# Staff Report PC23-057-PP

## Windswept Farms Primary Plat

### Docket PC23-057-PP – Primary Plat – Windswept Farms

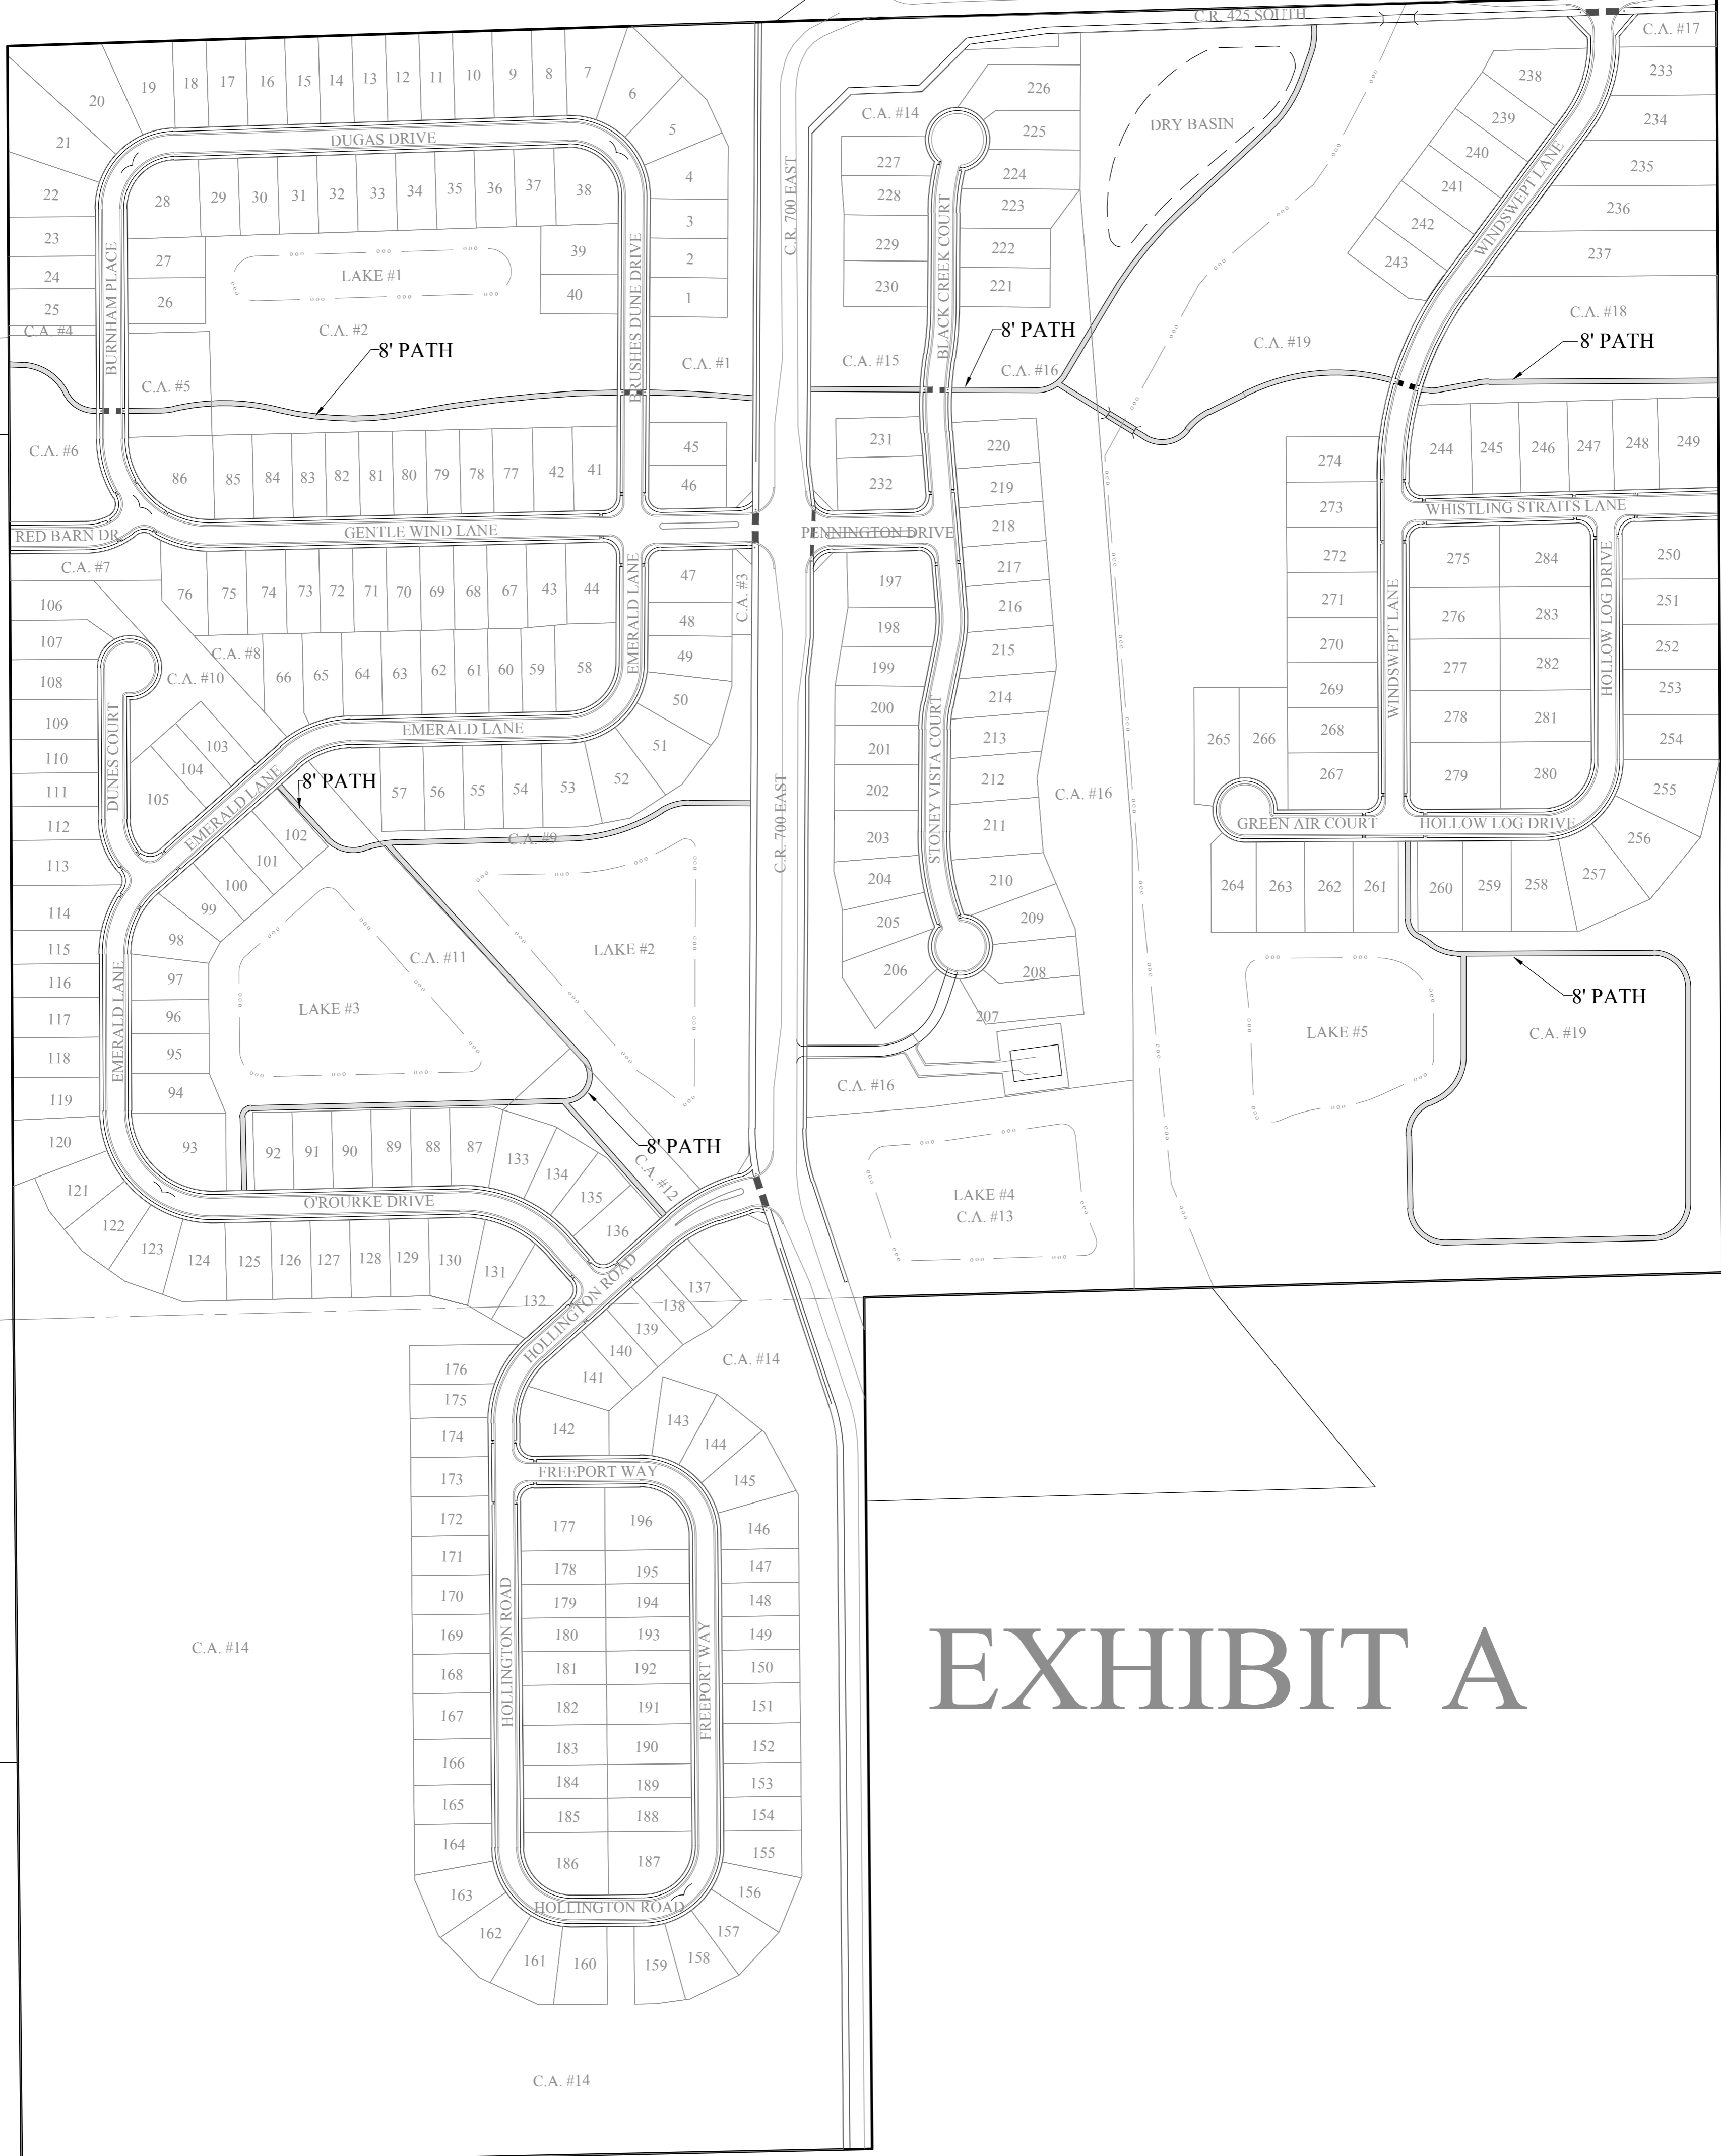
**Petitioner Substitution Request:** To substitute the historic barn, existing house, parking, trail system, and 50 acres of tree preservation areas as the amenity center requirement of UDO Article 9.11 (H)(2).

**Staff Recommendation:** Staff is in support of the amenity substitution request according to the petitioner’s request as outlined in “Exhibit C” dated “2/2/24” in addition to the clubhouse standards outlined in Article 9.11 (K) of the Whitestown UDO.

1. Provide a rapid flashing signal (RRFB) at the northern trail intersection of C.R. 700 East.
2. Provide a rapid flashing signal (RRFB) at the southern trail intersection of C.R. 700 East.
3. Trail connection resembling the example shown in Article 9.4(D)(2) connecting the 5’ sidewalk to the 8’ path on the east side of CR 700 E.
